Attachment A

4 February 2026

1. Consistency with Strategic Planning Framework

Figure 2. Indicative envelope of Hay Street Carpark Site

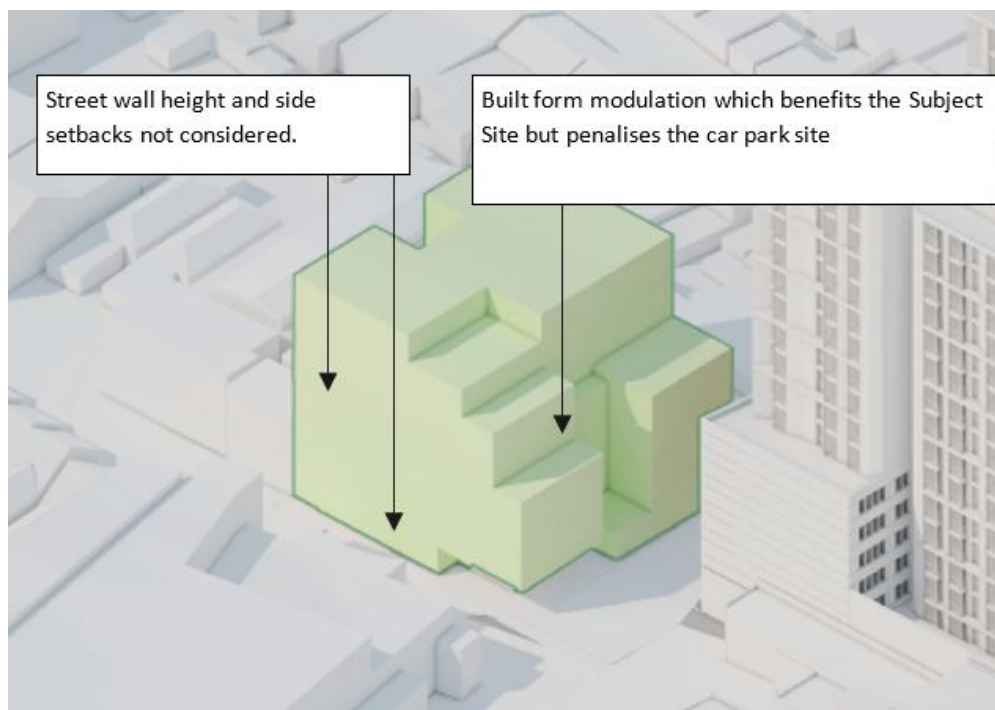
The proposal will adversely affect the potential development of the adjacent Council-owned public car park which Council has identified for delivery of 100% affordable housing as part of any future redevelopment. Under OFFP and using the Affordable Housing SEPP, the site could achieve up to 2.95:1 FSR and 36.95m (10 storeys), significantly above what is assumed in the SSD's urban design report.

The reduced envelope is driven largely by the overscale 6 storey podium on the SSD site and maximising its solar access, resulting in building modulation that benefits the SSD site but penalises the carpark site (see below image). The

proposed massing would result in burdening Council-owned site to provide additional setbacks, which should be equally distributed between the sites. It also fails to consider key site-specific controls, including required upper-level setbacks to Hay Street and side setbacks to the northern boundary.

Overall, the SSD proposal fails to account for the full redevelopment capacity of adjacent sites and does not demonstrate how overshadowing, solar access and built form impacts from a compliant redevelopment would be accommodated in its design.

Figure 4. Proposed building setbacks and separation and non-compliance tower form

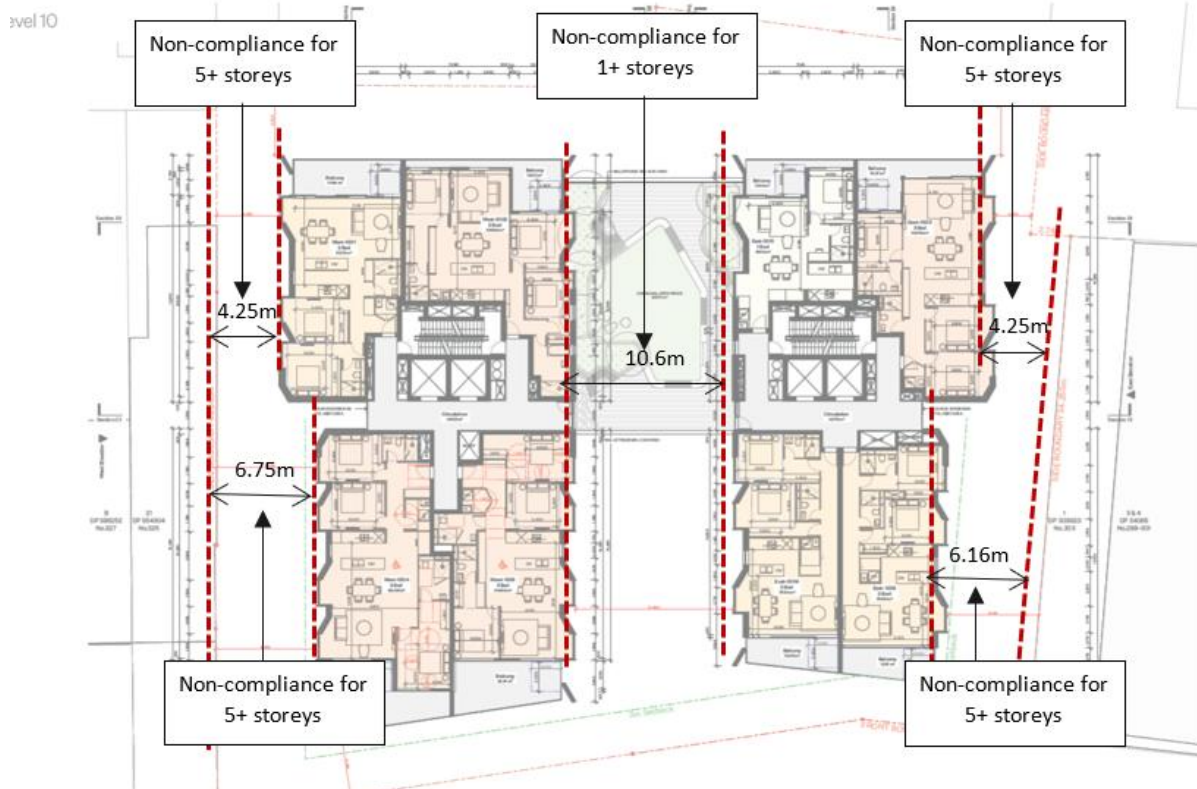
- Insufficient separation distance between the tower forms and non-compliance with ADG, particularly in between habitable rooms at the upper levels, represents an overdevelopment of the site which will compromise the amenity of the future residents and surrounding existing residents.
- Unless the subject site is amalgamated with the adjacent sites, its width is not sufficient to accommodate dual tower form that is ADG compliant and can respectfully meet all the required building setbacks and separation distances.

- The proposed side setbacks (4.25m and 6.1–6.8m) for the tower components do not comply with ADG requirements, which requires:
 - Minimum 6m setbacks for 5–8 storeys, and
 - Minimum 12m setbacks for 9+ storeys where habitable rooms face each other.
- The proposed 10.6m tower separation is also significantly below ADG minimums, which require:
 - 12m separation up to 4 storeys,
 - 18m for 5–8 storeys, and
 - 24m for 9+ storeys between habitable rooms.
- Although the design uses reeded glazing to mitigate privacy impacts, this does not address the fundamental non-compliances with setbacks and separation and is not considered to be an acceptable design response.
- Increased setbacks with single storey tower form will assist with meeting ADG requirements.

Figure 6. Applicant's indication of a future land dedication for public road shown in red shaded area for the northern laneway, Appendix 7 Urban Design Report (page 67)

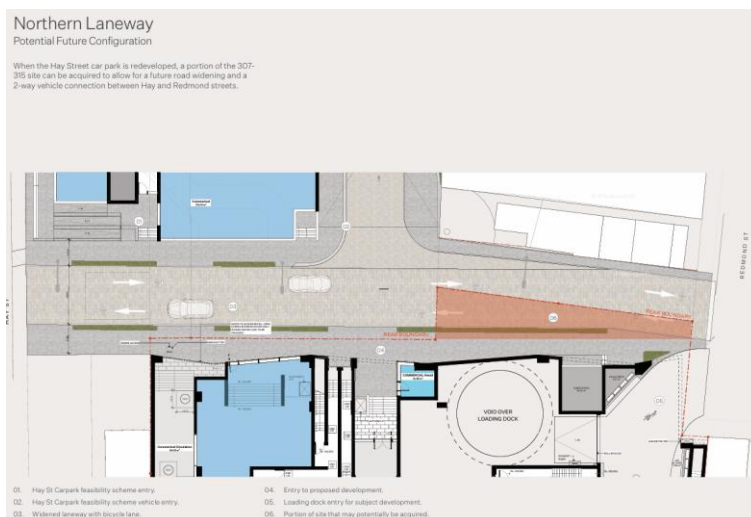
- Reference is drawn to page 67 to Appendix 7 of the Urban Design Report, in particular the statement that “When the Hay Street car park is redeveloped, a portion of the 307-315 site can be acquired to allow for future road widening and a 2-way vehicle connection between Hay and Redmond Street”. The diagram accompanying the statement is provided below, noting the red shaded area as the applicant’s earmarked future land dedication area. The future land dedication is also stated on page 14 of Appendix 10 Stormwater Plans. The applicant’s statements acknowledges that road dedication is required to facilitate the surrounding lots’ redevelopment.

- PRCUTS Urban Amenity Improvement Plan provides a framework for public domain and active transport improvements to support the uplift in residential densities. The Strategy identified a cycle link through Dot Lane that runs from Hay Street to Norton Street, with improvements connecting the existing cycle path along the northern boundary of the subject site.

- The SSD proposal considers a potential 12m wide laneway reserve between the subject site and Council's Hay Street Carpark site. It does not however clarify how this will be facilitated. It also does not provide adequate setbacks to achieve this 12m width. For example, at the intersection with Redmond Street, the proposal seeks to contribute to the public domain with 1.2m land dedication which will only facilitate 6.4m width for the laneway, against its own vision to provide 12m wide laneway.

Figure 7. Land to be dedicated to Council to accommodate 9m wide laneway reserve between Redmond Street and Hay Street.

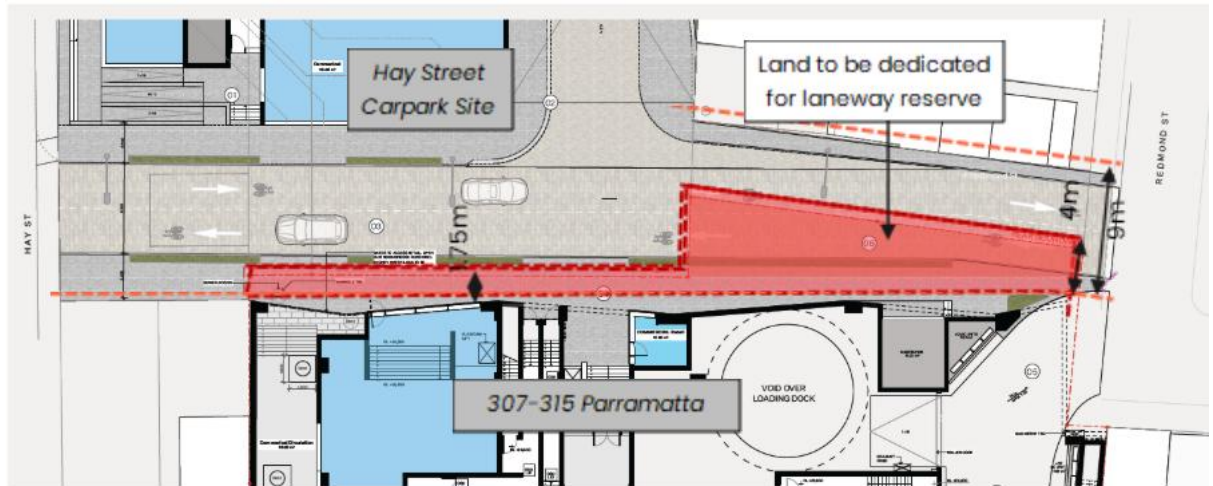
- A minimum width of 9m is required to facilitate the cycleway/shared zone connection. This means that a minimum 4m wide dedication from the northeast portion of the site is required.

- This will allow this laneway to continue along Redmond St which is also currently 9m wide.

- The proposal must dedicate this land to facilitate the public domain improvements. The design should also be amended, including siting of the development and access, and extent of the basement encroachment, consistent with Council's aspirations.

- Secure land dedication for public infrastructure (local road dedication) between Redmond St and Council's car park (13 Hay St) that facilitates a public road width of 9m that accommodates a shared way, footpaths and landscaping, as a condition of rezoning and at no cost to Council.
